# J&T Consulting, Inc.

July 20, 2020

*RE: Northern Colorado Constructors, Inc. – Bennett Pit – Response to Inspection Report for CT-1  
File No. M-2016-085*

## 36 in CMP Capacity

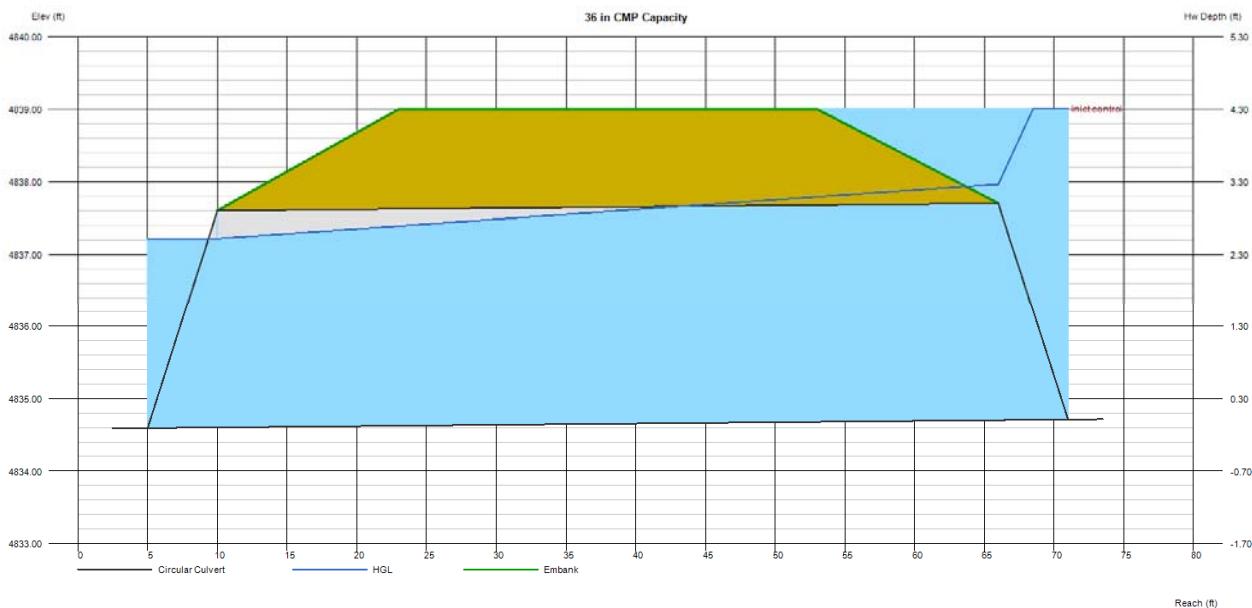
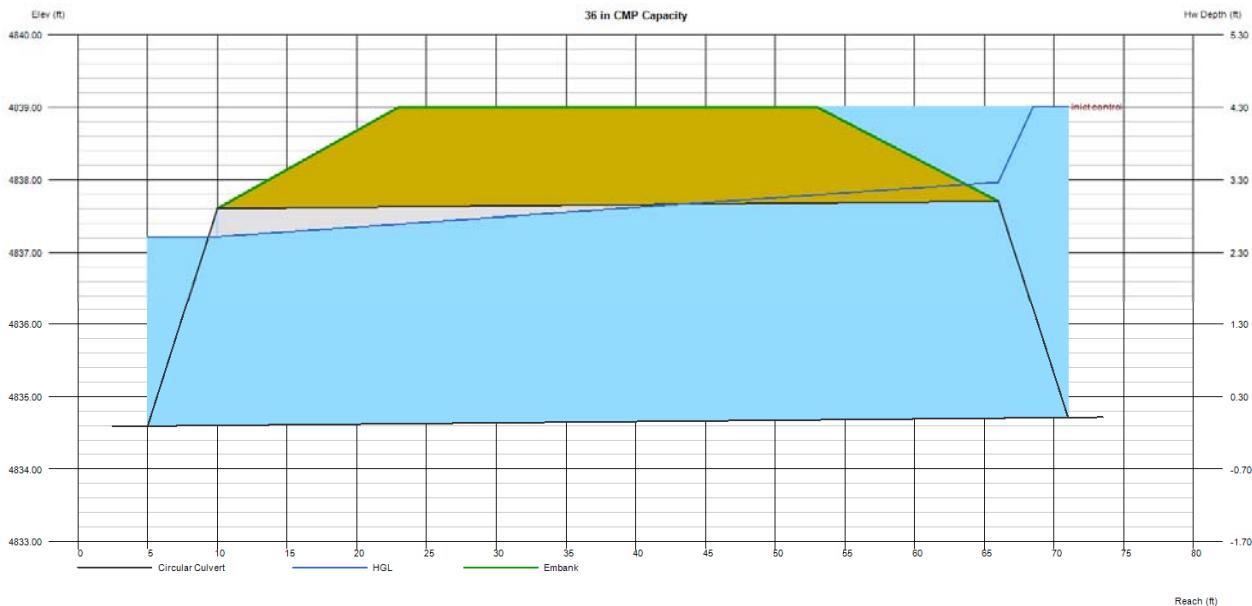
The 36 inch CMP culvert crossing the entrance road was sized to take the 10-yr frequency storm runoff. This is the same frequency that the culvert crossing (30 inch equivalent CMP culvert) on CR 22.5 is sized to take per Weld County's design criteria where the culvert must pass the 10-yr flow with no more than 6 inches of water overtopping the roadway. We used the same peak flow to compare to check the capacity of the existing 30 inch equivalent CMP at CR 22.5. Culvert calculations are included in the attachments.

We believe the current design meets the requirements of Weld County regulations for rural county roads, however NCCI is willing to add additional 36 inch culverts to accommodate the 25-yr peak flow. Five additional 36 inch CMP culverts are needed to pass the 25-year storm without using any capacity of the two existing 20 inch HDPE culverts (capacity of two 20 inch culverts is 20 cfs). During the larger storm events (50-yr and 100-yr) these areas are inundated as part of the floodplain. Larger culverts will not provide a benefit to draining the water from the area since it is within the floodplain.

Six 36 in culverts would be required to convey the 25-Year storm event

100-yr Floodplain Elevation Summary  
© 2020 J&T Consulting, Inc.

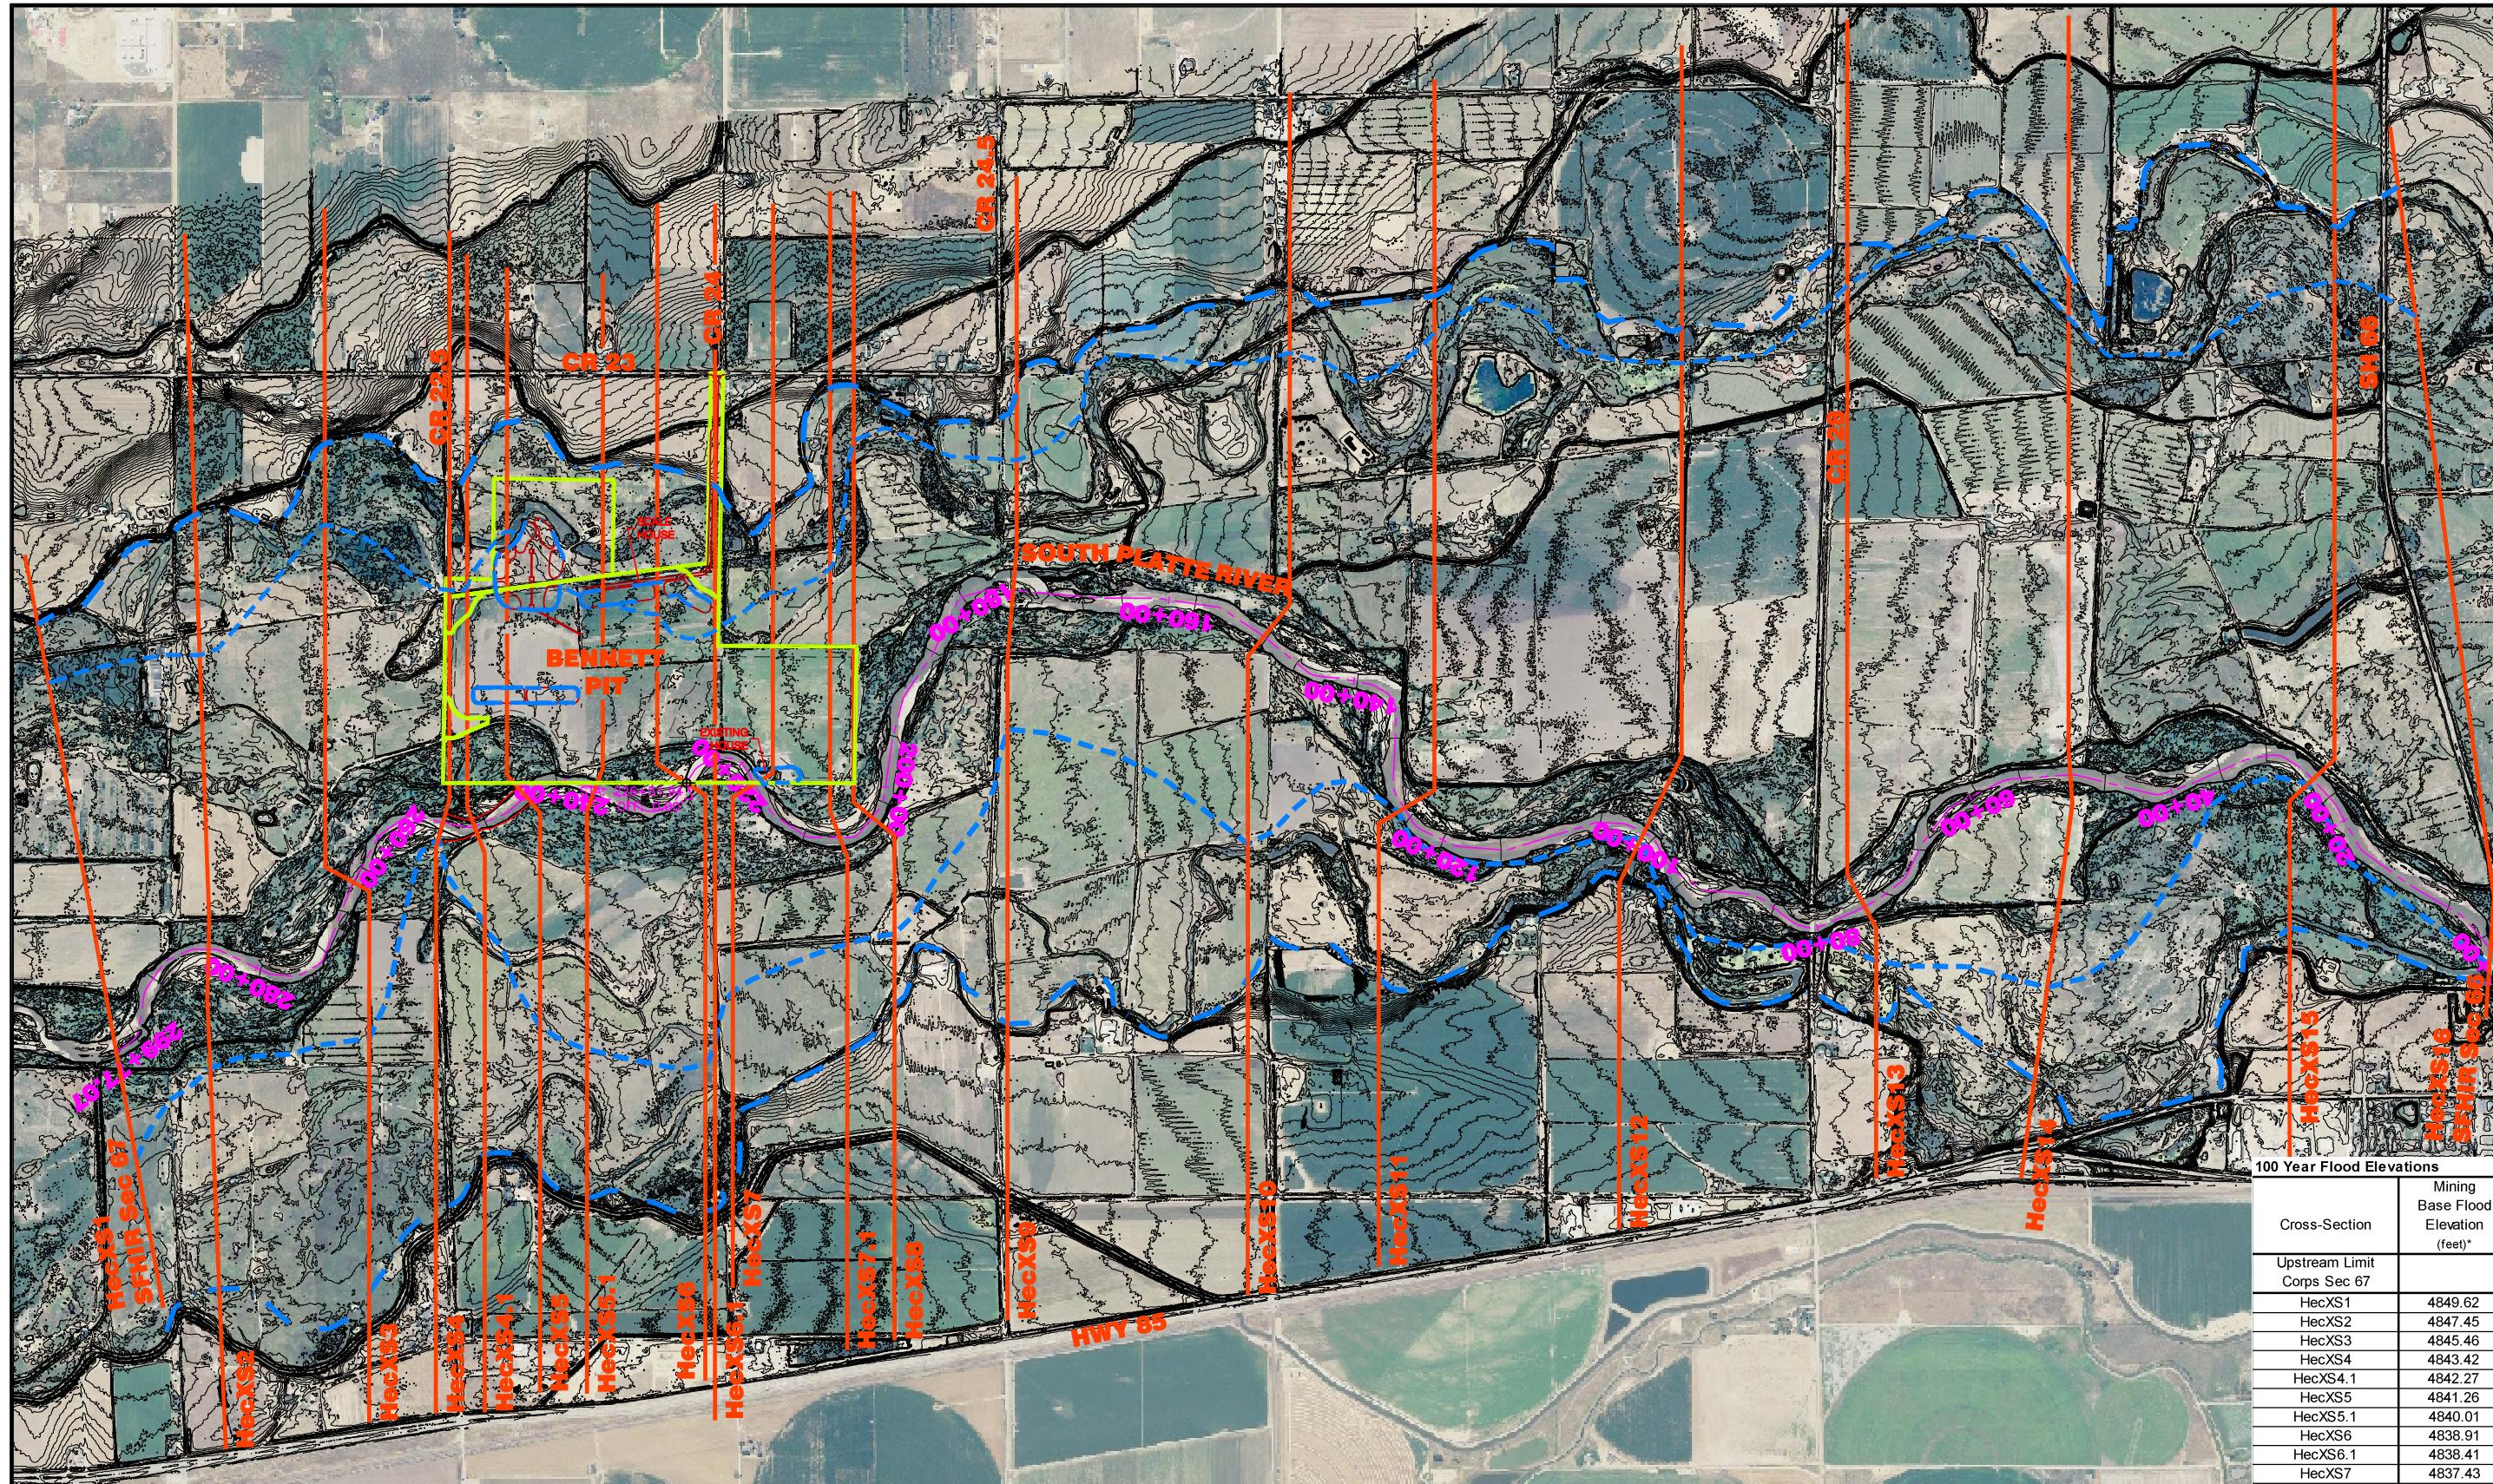
the entrance road into the mine. The Colorado Urban Hydrograph procedure was used per Weld County's design criteria to generate the storm runoff peak flows. We have also included the floodplain modeling results for the existing condition, the mining condition, and the future reclaimed condition that shows no rise in the 100-yr base flood elevation for the entrance road.
